MANATEE COUNTY

May 22, 2013

SUBJECT: Invitation for Bid #13-1089-OV
44th Avenue East – From U.S. 41 (1st Street) to 19th Street Court East
Project Nos.: 334-6001060 and 319-6045661

ADDENDUM #2

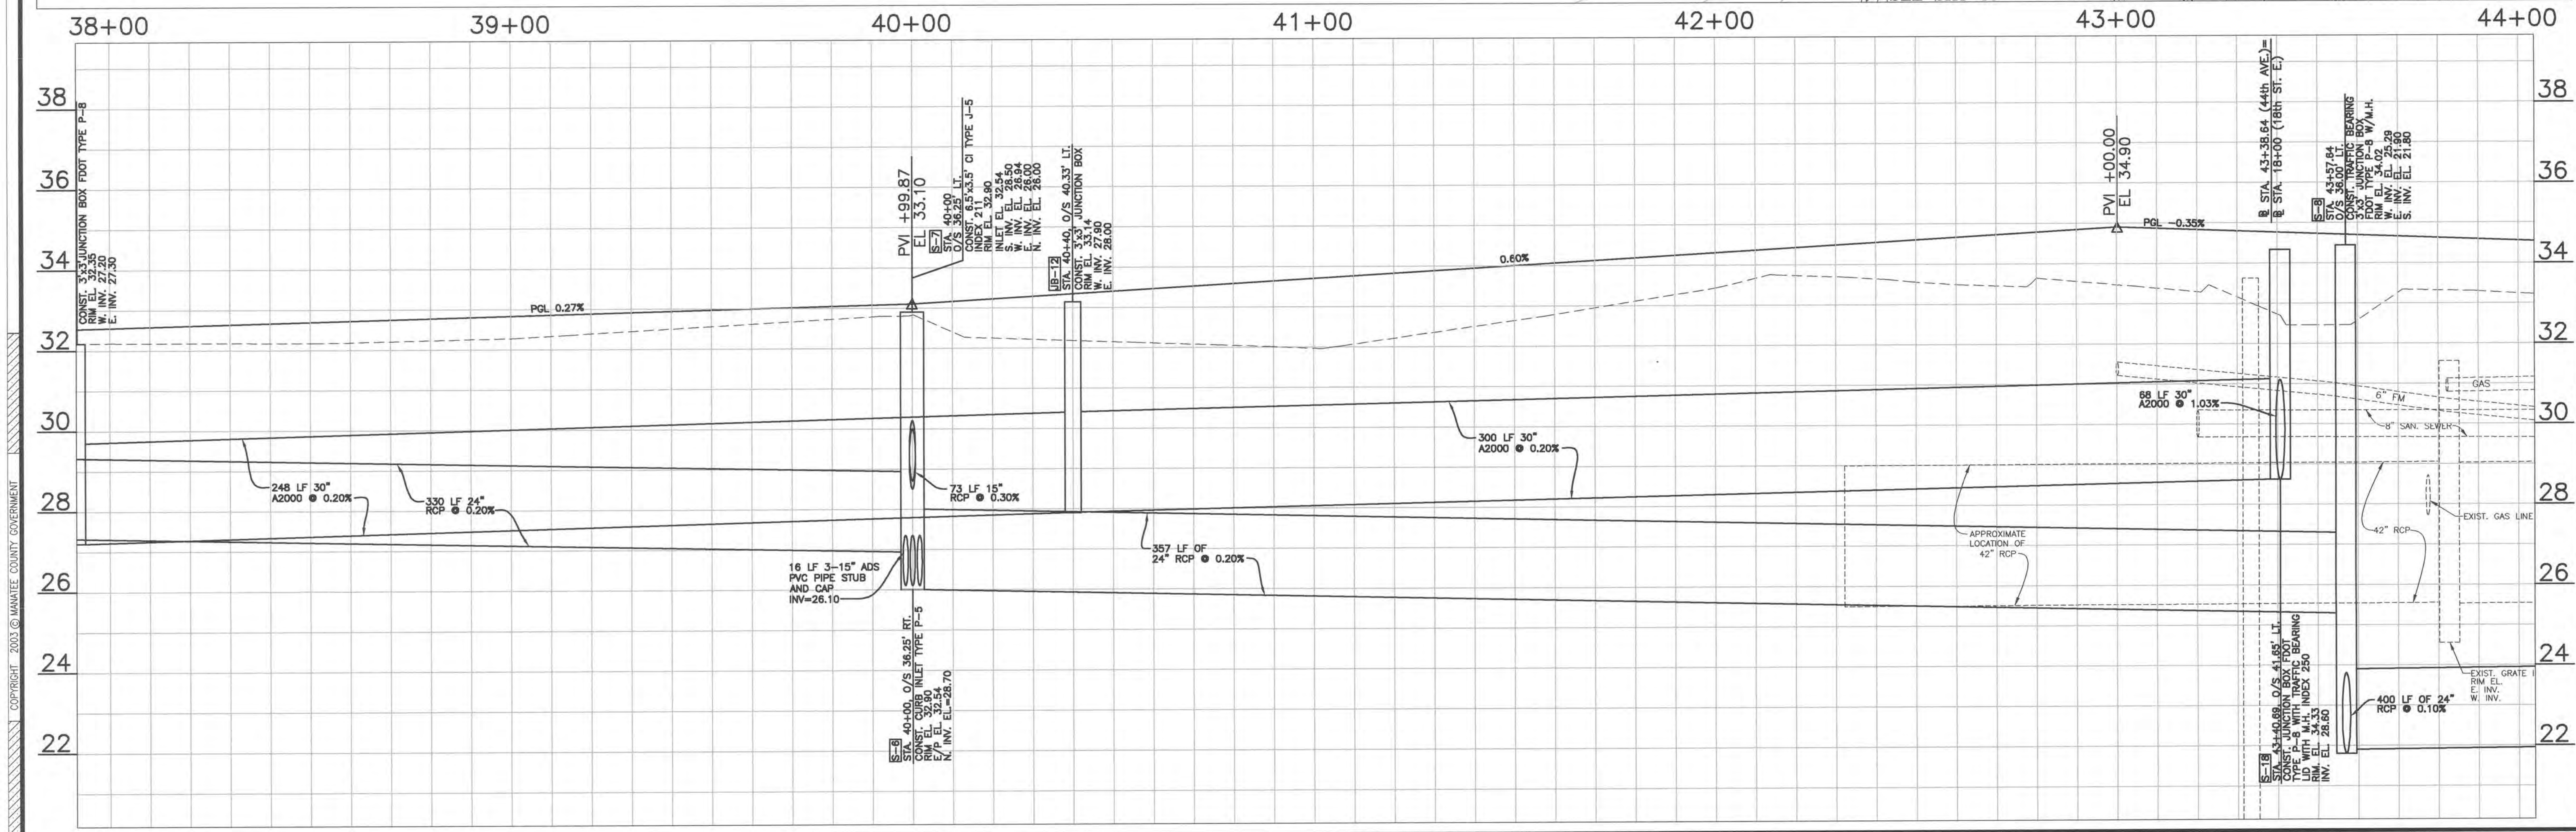
Question 9: Reference bid item R30, P5 Curb Inlets <10', bid form shows 4-each, I find 7-each, please clarify.

Response 9: The quantity of bid item no. R30, P-5 Curb Inlet <10, has been updated as 7. Sheet 26, Curb Inlet at St 36+70 RT shall be labeled as "P5" in lieu of "P-6".

REVISION	BY	DATE
① NEW FENCE PER CONTRACT WITH PIERCE MANUFACTURING		5/15/13
② SWK AND ELEVATIONS REV.		5/08/13
③ UNDERLAYMENT ADDED PER CSX		
SURVEYED	MSL	5/20/08
DESIGNED	CM/SF	7/08
DRAWN	DF/MRJ	7/08
CHECKED	CZ	
SCALE: 1"=20'		
SEAL		
APPROVED BY:		
CHRISTOPHER LEE MOWBRAY FLORIDA P.E. # 46777 MANATEE COUNTY GOVERNMENT PUBLIC WORKS DEPARTMENT 1822 26TH AVENUE EAST BRADENTON, FL. 34208		
DATE	5/15/13	
SHEET 26 OF 115

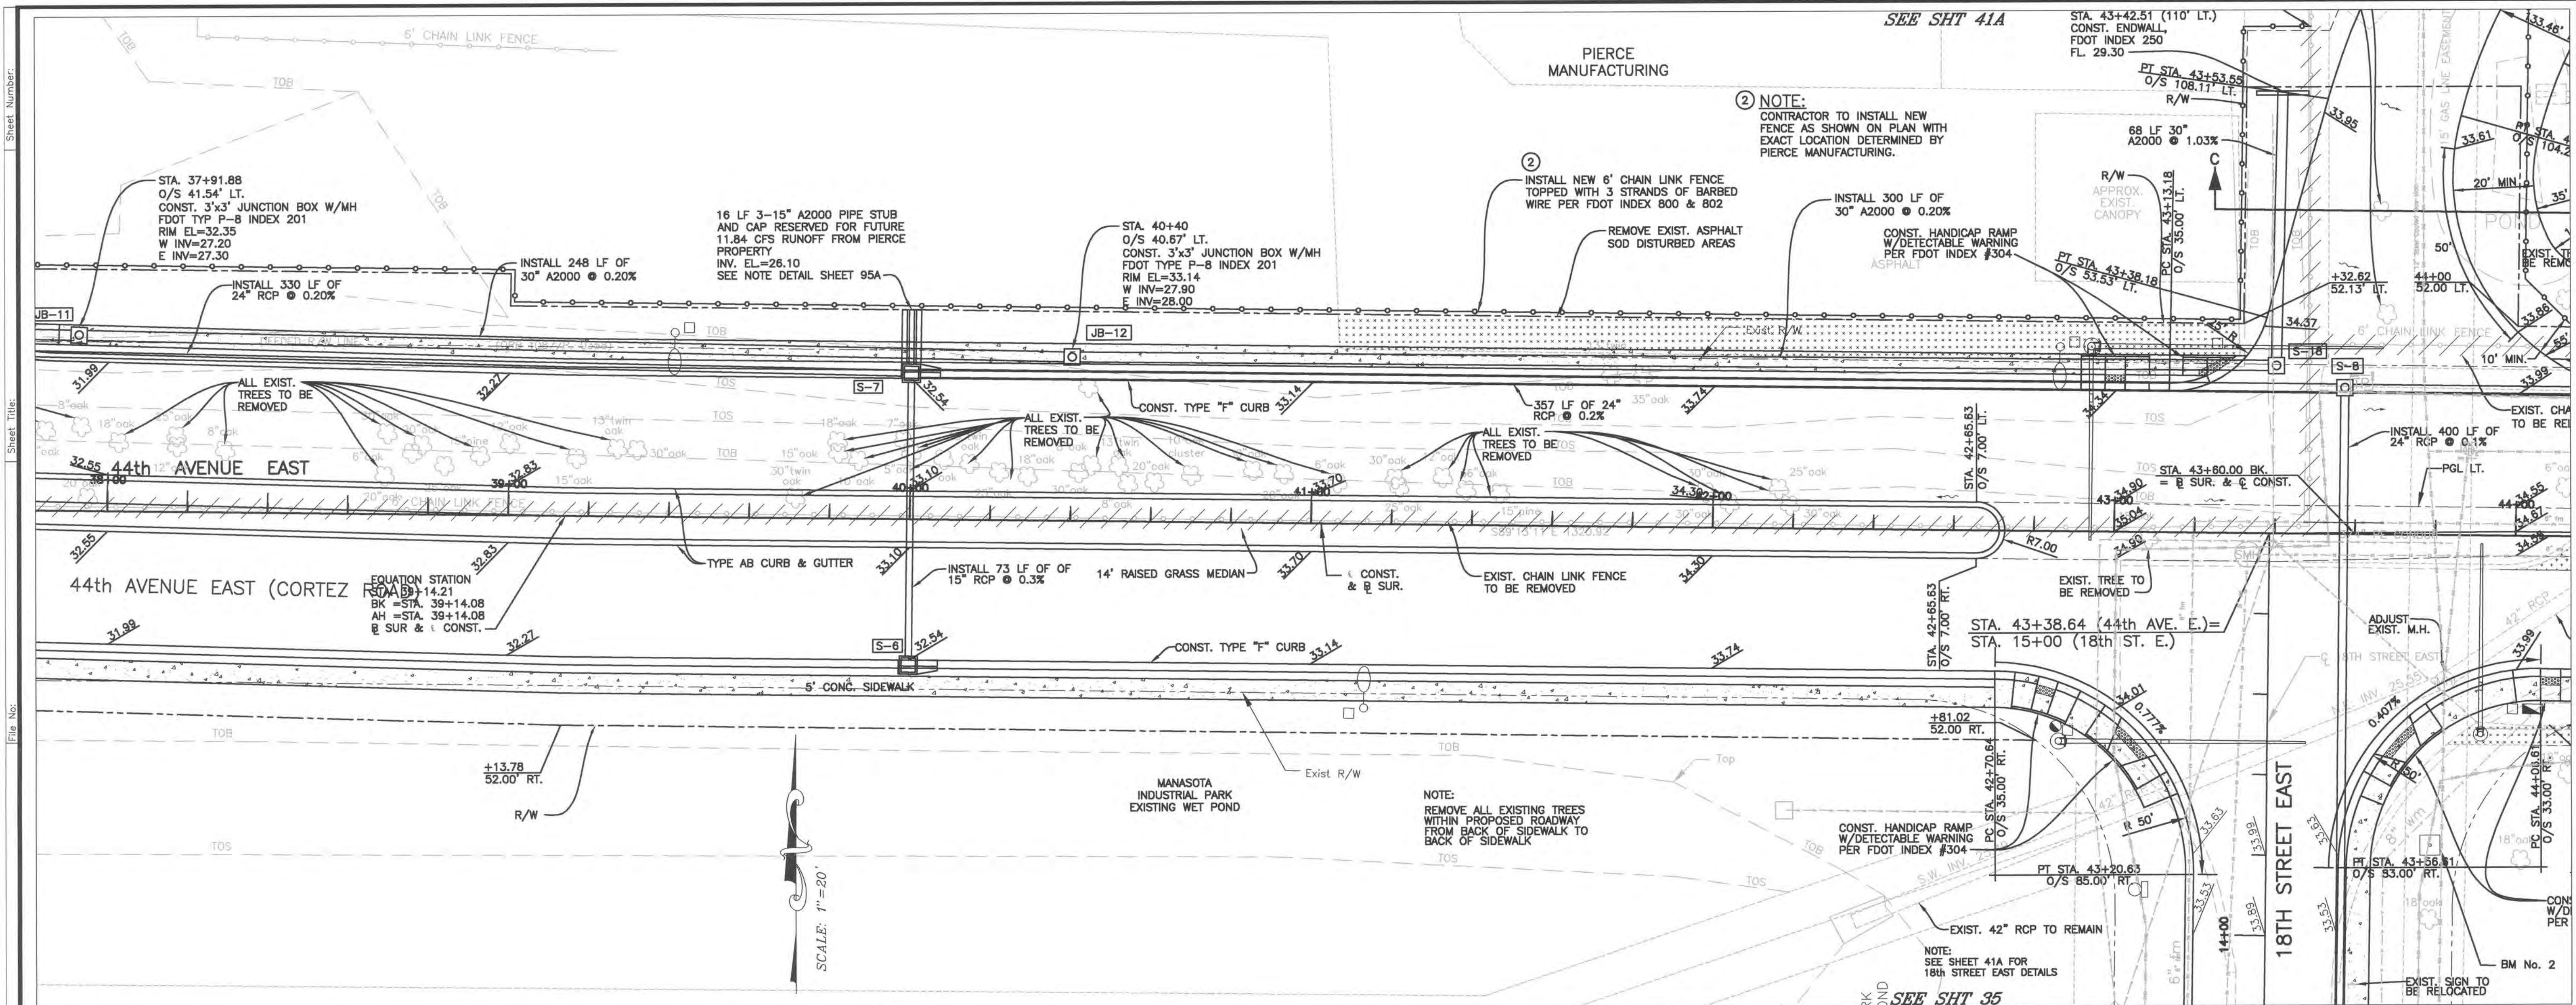
NEW FENCE PER CONTRACT WITH PIERCE MANUFACTURING	5/15/13
REVISION	DATE
BY	DATE
SURVEYED	MS/SF 5/20/08
DESIGNED	CM/SF 7/08
DRAWN	DF/MRJ 7/08
CHECKED	CZ
SCALE:	1"=20'
CHRISTOPHER LEE MOWBRAY FLORIDA P.E. # 48717 MANATEE COUNTY GOVERNMENT PUBLIC WORKS DEPARTMENT 1022 26TH AVENUE EAST BRADENTON, FL 34208	
DATE	5/15/13
SHEET 27 OF 115

NOTE:
CONTRACTOR TO INSTALL NEW
FENCE AS SHOWN ON PLAN WITH
EXACT LOCATION DETERMINED BY
PIERCE MANUFACTURING.
